ENGINEERING QUERY

Project: Test Project 01	Project No.: 0001TP
Action no: 0001TP-0001-ABC-ACME-EQ-0009-01	Status

Title: **Guidelines to Working Environment**

Discipline: **Working Environment** PO No. **0001** Package: **AA-0000-01 Knock Out Drums (KOD)**

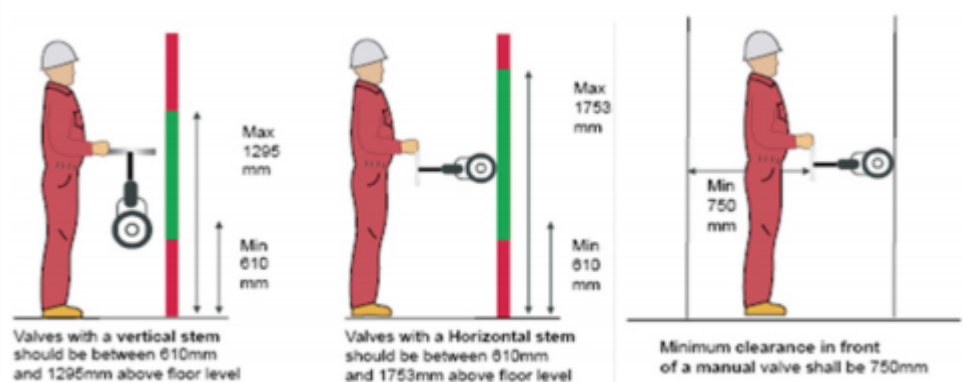
Following the 60% Plot Plan review, Contractor observed that the operating height of valves are not clearly defined in the COMPANY specification XYZ.

Contractor recommends the operating height for different types of valves as per industry practice. Kindly approve the recommendation to submit the Contractor's drawing: Valve ergonomic arrangements.

Agreed, it will be implemented for pump skids also.		
Issued For:	Clarification	
Prepared by: Contractor User	Organization: Contractor	Date: Mar 25, 2018
Approved by: Contractor Approver	Organization: Contractor	Date: Mar 25, 2018

Mar 25, 2018 - Rev. 00		
Noted, It's also applicable for Pump Skids		
Rev. 01		
noted. please proceed		
	Approved	
	Approved with Comments	
	Rejected	
	Rejected with Comments	
Prepared by: Company User	Organization: ACME Company	Date: Mar 25, 2018
Approved by: Company Approver	Organization: ACME Company	Date: Mar 25, 2018
